**Hallsville R-IV School District
Proposition 2**

**Primary School
Gymnasium & Classroom Additions**

Progress Report #17
July 2020

S. M. Wilson & Co. has submitted Change Orders #41 through #45. We have listed a summary of each change order below. Please review each change order and let me know if you have any concerns.

1 PA SYSTEM ZONES
 1" = 30'-0"

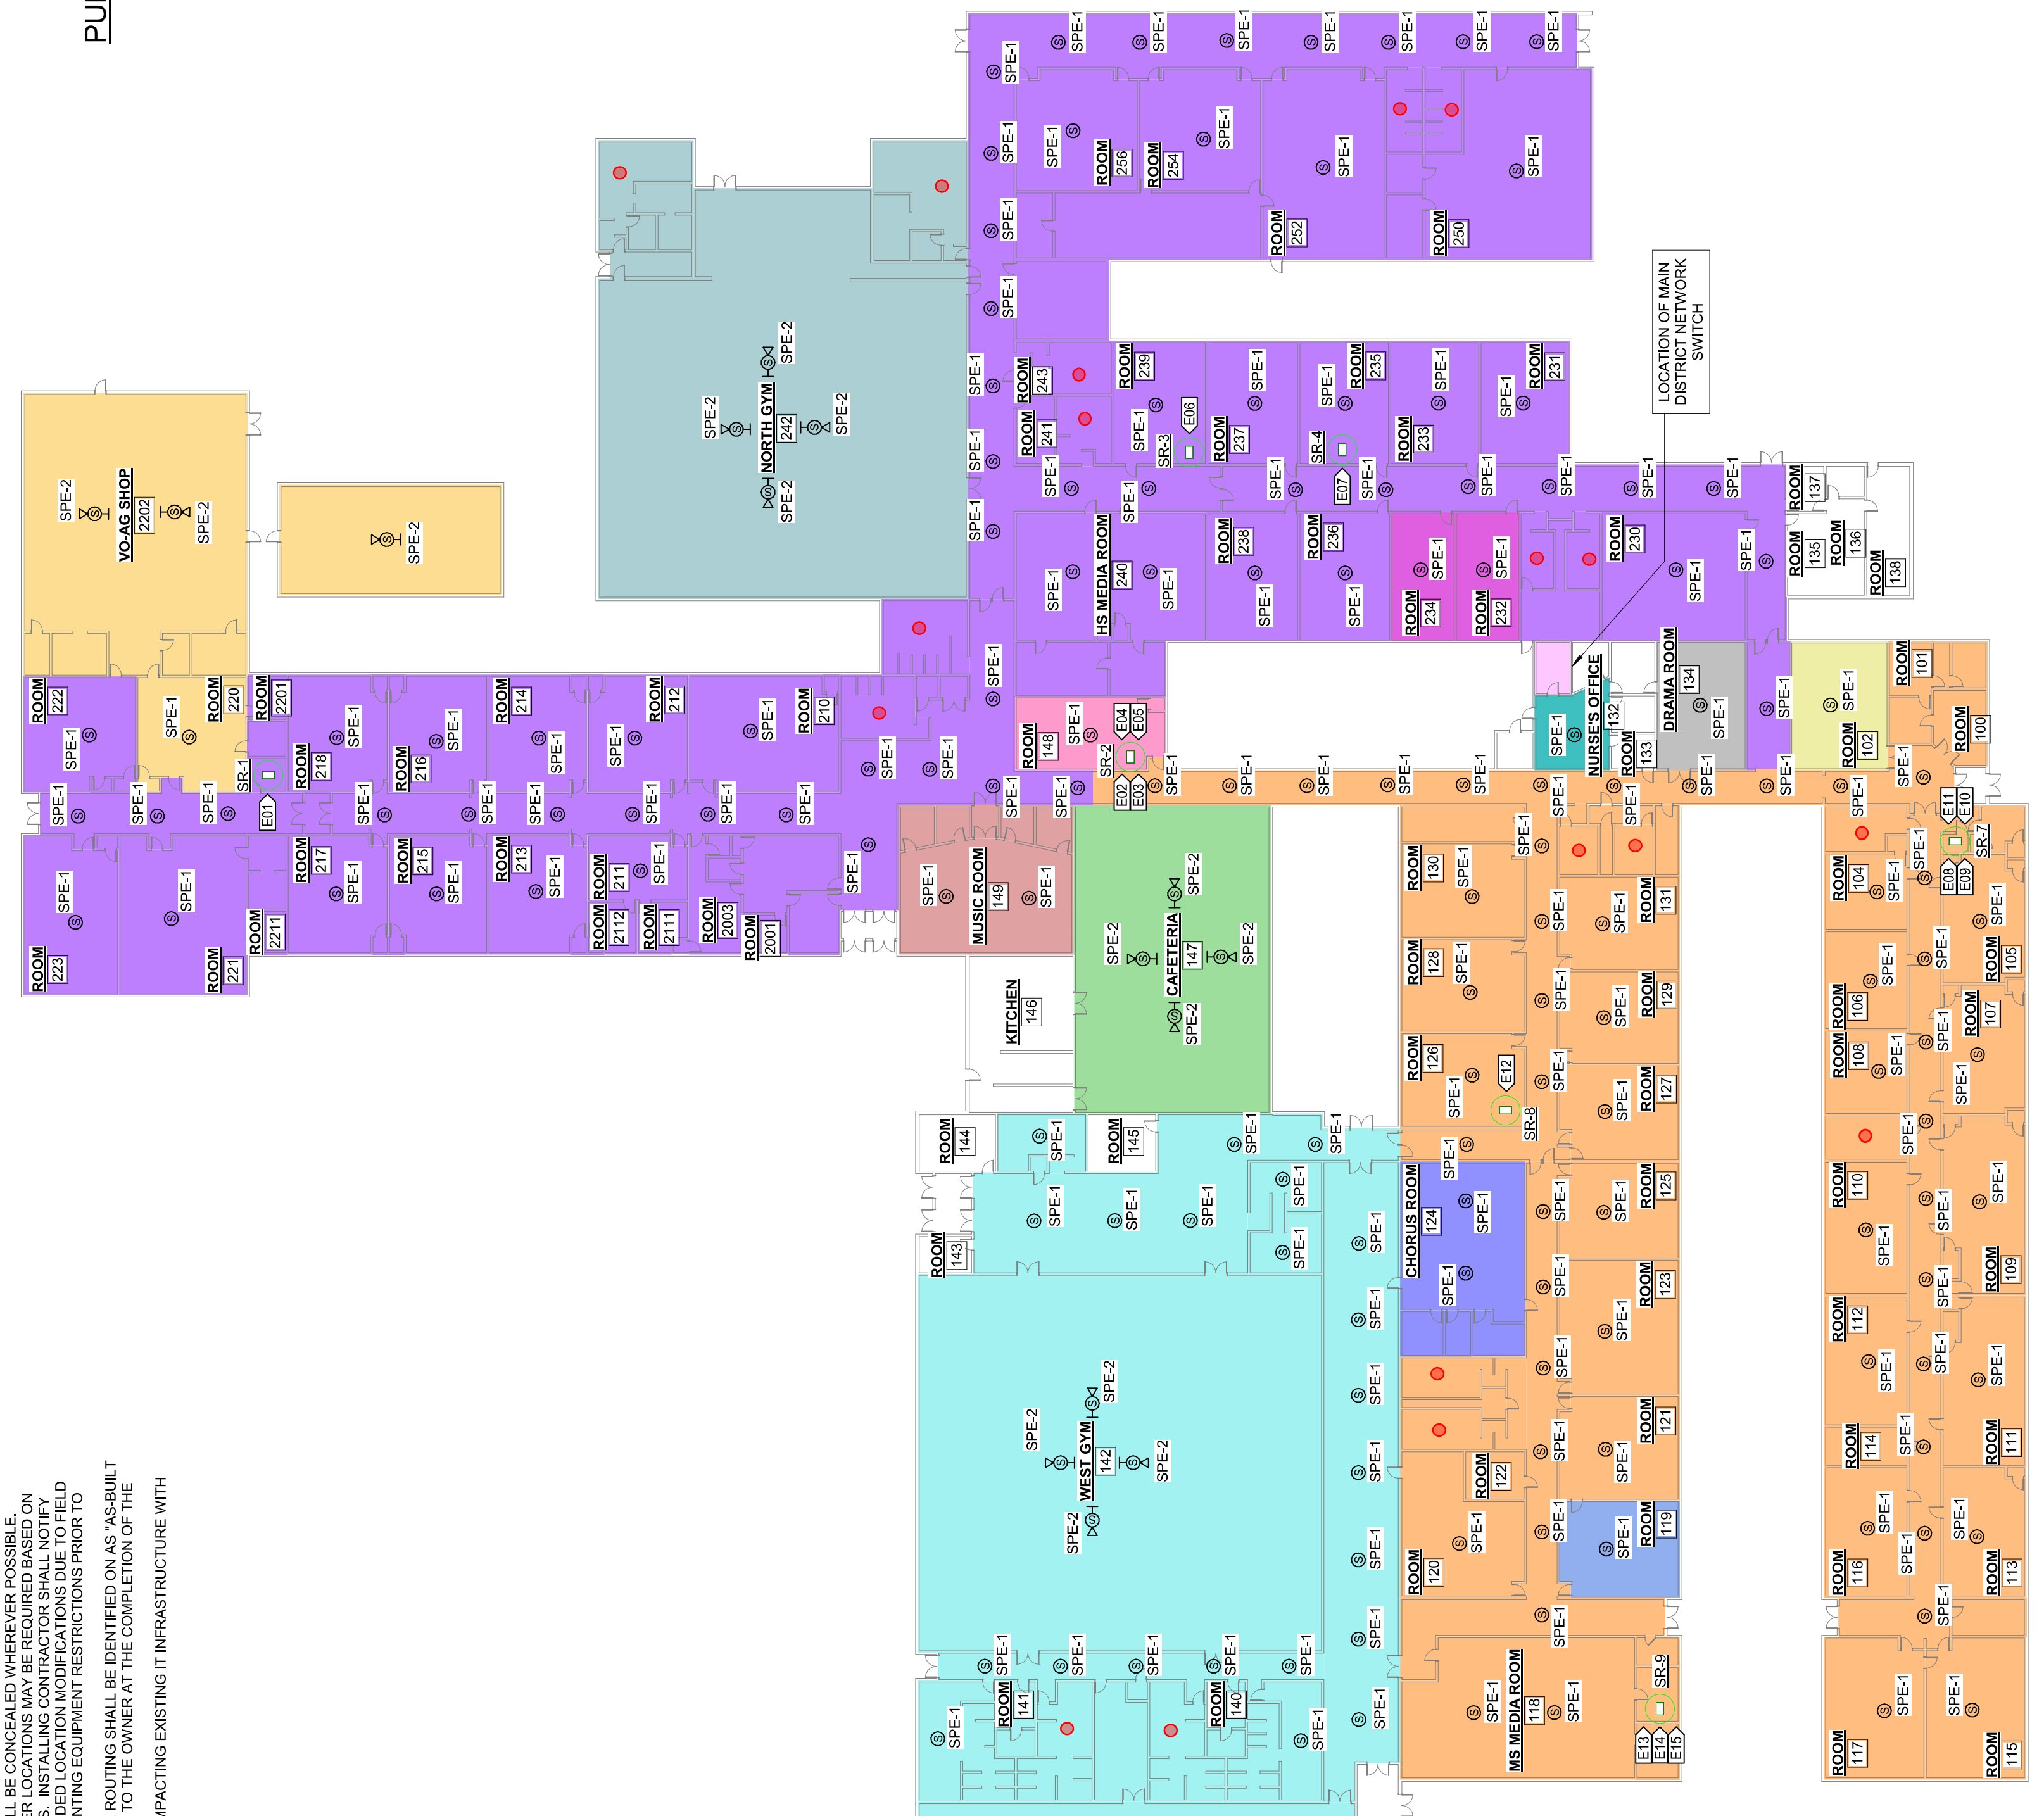
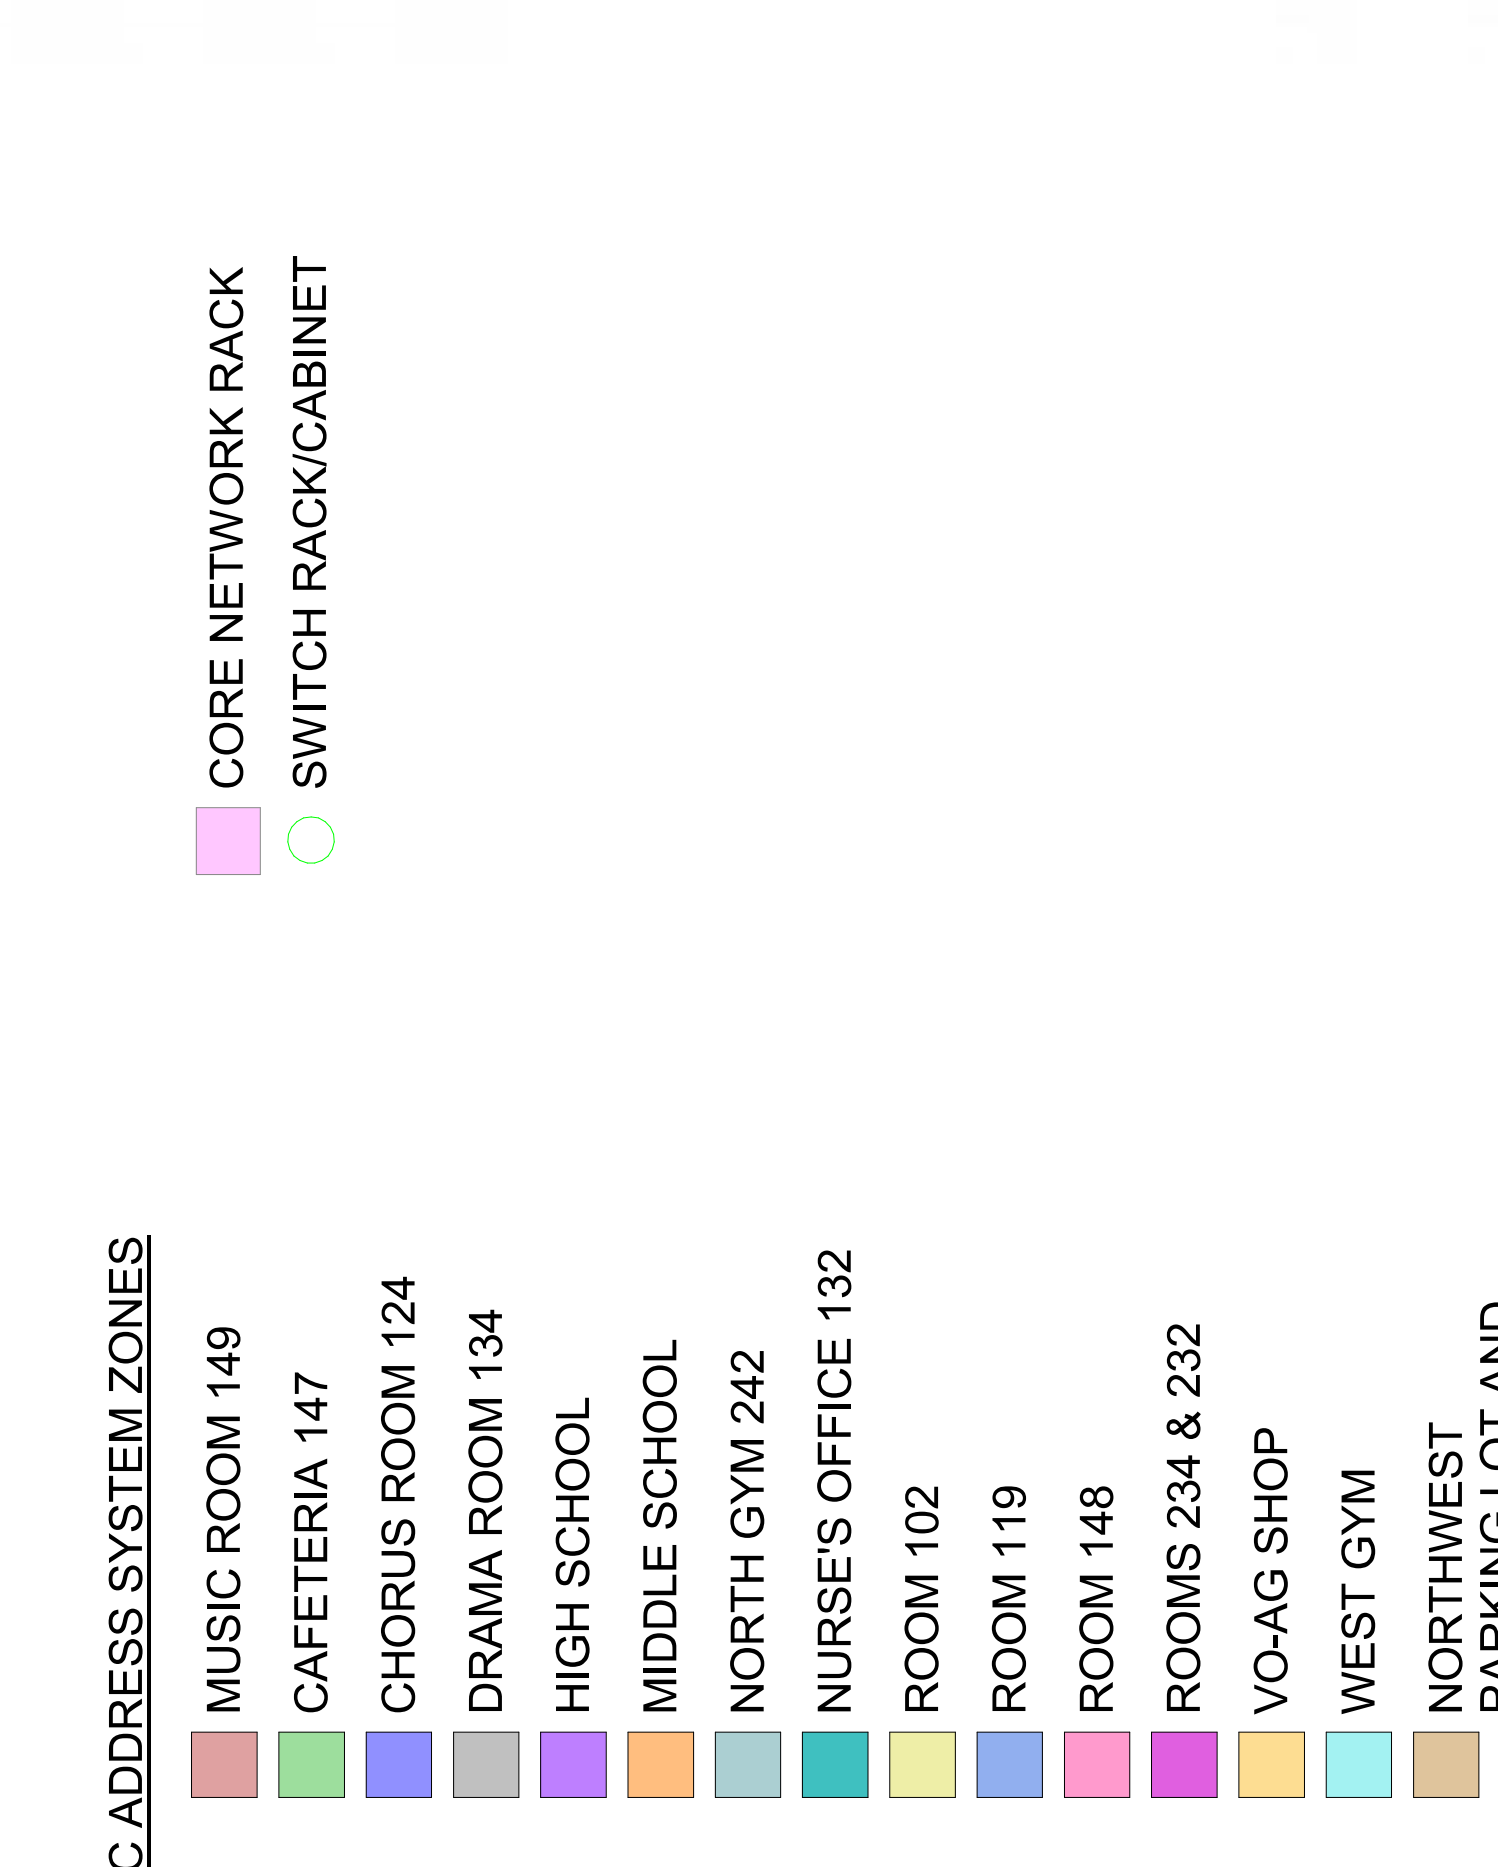
Description	Net Amount
Towner	
Furnish and install (18) eighteen additional speakers in the existing High School / Middle School. Reference revised layout provided by Klingner. See Towner quote 14521.	5,570.36
Owner's Contingency	
This is to be funded from Owner's Contingency.	(6,042.85)
Subtotal:	\$(472.49)
SDI (Subcontracts):	\$69.63
SDI (Purchase Orders):	\$0.00
Performance & Payment Bond:	\$60.43
General Liability:	\$60.43
FEE:	\$282.00
Total Cost:	\$0.00
